ADDENDUM COUNCIL ASSESSMENT REPORT

SYDNEY EASTERN CITY PLANNING PANEL

PANEL REFERENCE & DA NUMBER	PPSSEC-238 – DA-483/2022
PROPOSAL	Construction of three buildings ranging in height between 5 and 7 storey containing a mixed use industrial, warehouse and recreational development with 2 basement levels for parking, storage and plant areas (Water NSW & Integrated Development).
ADDRESS	Lot 2 DP 261143, Lot 1 DP 219847, Lot 3 DP 271143 2-6 Girawah Place, Matraville
APPLICANT	Mr Agy Dassakis, Spirecorp Pty Ltd
OWNER	Spirecorp Pty Ltd
DA LODGEMENT DATE	4 October 2022
APPLICATION TYPE	Development Application
REGIONALLY SIGNIFICANT CRITERIA	Clause 2, Schedule 6 of <i>State Environmental Planning Policy (Planning Systems) 2021</i> : Development that has a capital investment value of more than \$30 million.
CIV	\$37,802,636 (excluding GST)
CLAUSE 4.6 REQUESTS	None
KEY SEPP/LEP	Transport and Infrastructure SEPP, Biodiversity and Conservation SEPP, Resilience and Hazards SEPP Randwick LEP

<ul style="list-style-type: none"> • Plan of Management (King Beats Fitness) • Gym Floor Plan Layout • Bunnerong Creek Plans • Waste Management Plan • Response Letter to Traffic Issues • Industrial Market C

Figure 14: Eastern Elevation Landscape Plan (Source: Drawing No. DA-2207-08 – Sturt Noble Associates)

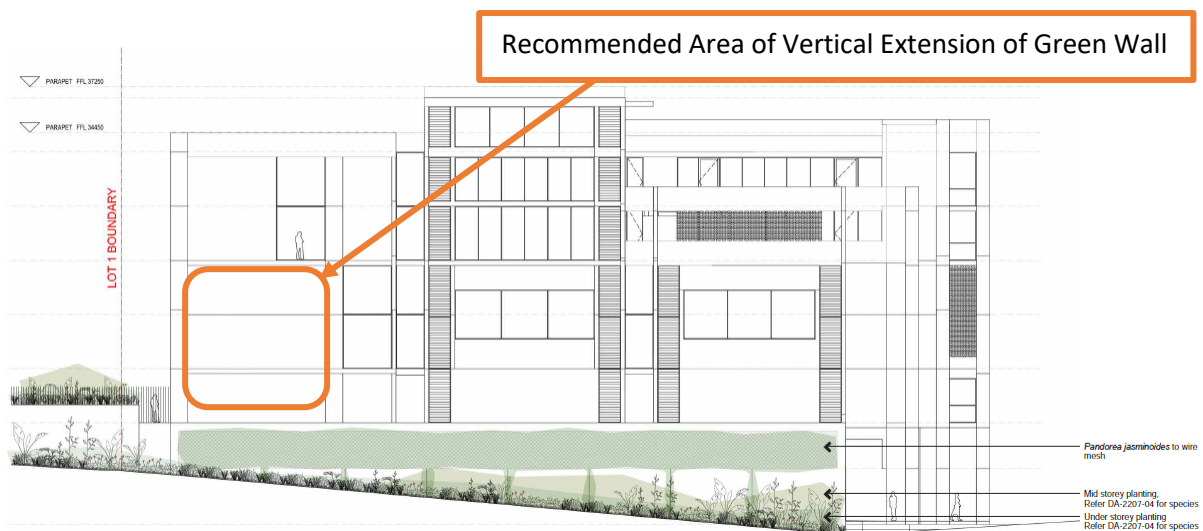
Finally, it is also recommended that the green wall be extended vertically on the southern portion of the elevation up to Level 2. The southern portion of the elevation in its current design remains largely visually unarticulated and can be enhanced by the extension of the green wall. Refer to the image below.

- The building on Lot 1 is to be modified to introduce an 8m setback to the eastern boundary on Levels 3, 4 and 5. The displaced floor area associated with the gym tenancy on Level 3, the outdoor play area of the child care centre on Levels 3 and 4 and the indoor recreation tenancy on Level 5 may be relocated within the 8m setback. An overall increase in the GFA proposed as a consequence of relocating floor area is not permitted.
- The eastern elevation of the aquatic centre level is to be modified to increase the size and amount of glazing to create an improved visual connection between the pool area and the RE1 Public Recreation zoned land.
- The green wall is to be extended vertically on the southern half of the east elevation of the building on Lot 1 to enhance the visual appearance up to and including Level 2.

Figure 15: Extract of Marked Up Services Plan Indicating Pipe and Child Care Centre Location

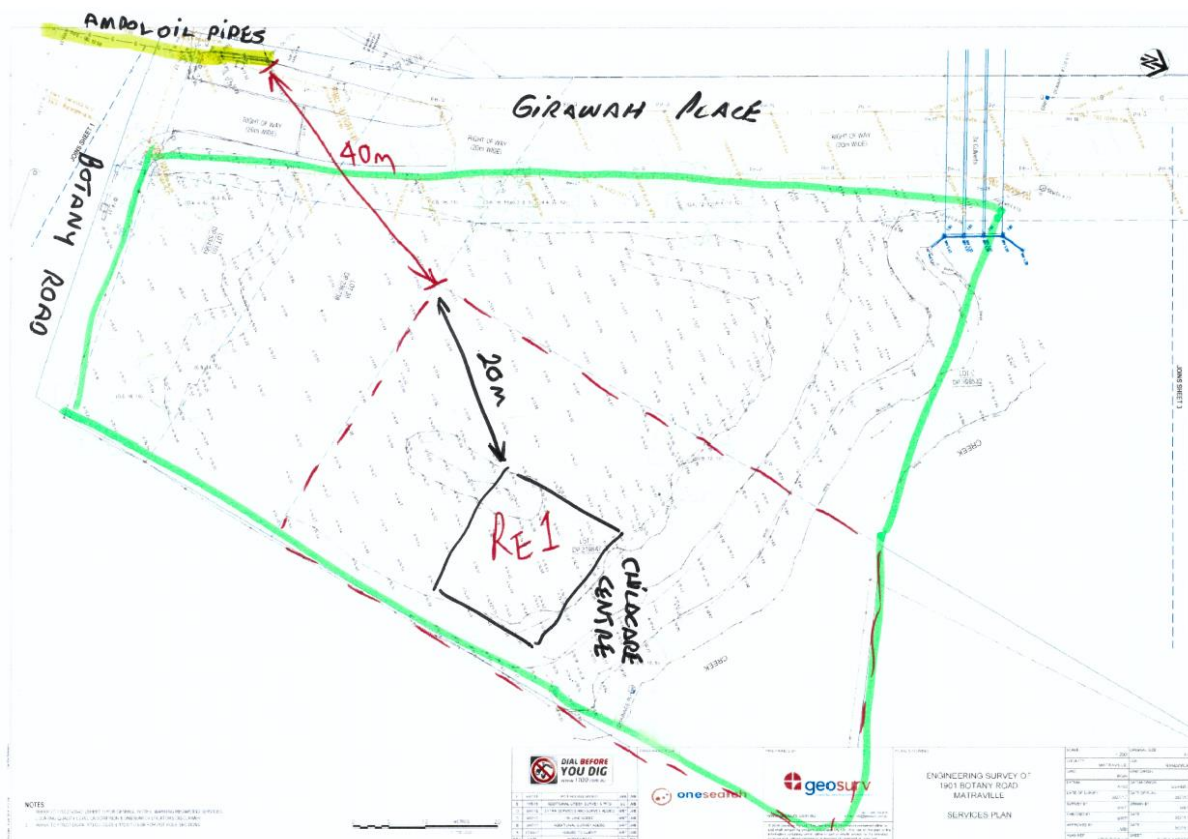
Regarding the high pressure pipeline, additional information was submitted identifying the location of the pipe and the distance to the proposed child care centre which exceeds 40m. See below a mark up of the services plan prepared by the applicant.

Correspondence was received from Ampol on 29 October 2023 confirming that the above information was sufficient to rescind the recommendation for a Safety Management Study.

Figure 16: Gym Fit-out Plan

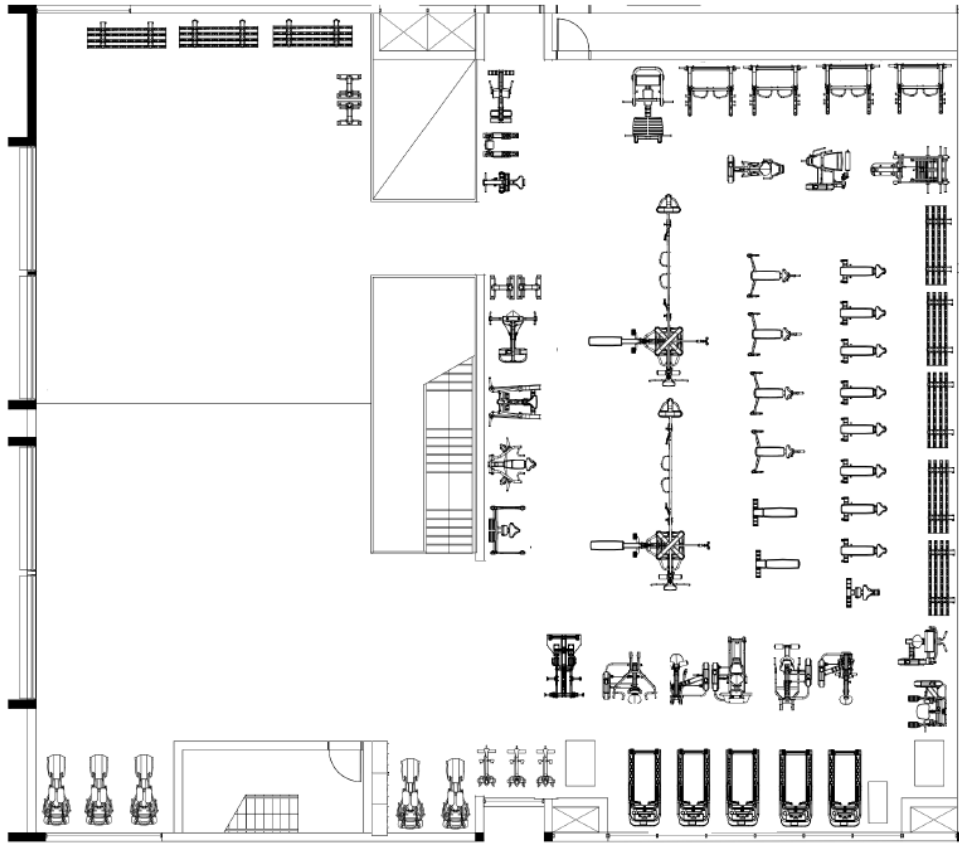
To support a gymnasium, a complete fit-out plan is required to inform the acoustic assessment. An acoustic assessment is a requirement in the Randwick City Council Development Application Checklist for any premises with 24 hours operations. The DA Guide necessitates the acoustic report to identify how the proposal will comply with the relevant standards including details of any noise attenuation measures to be included.
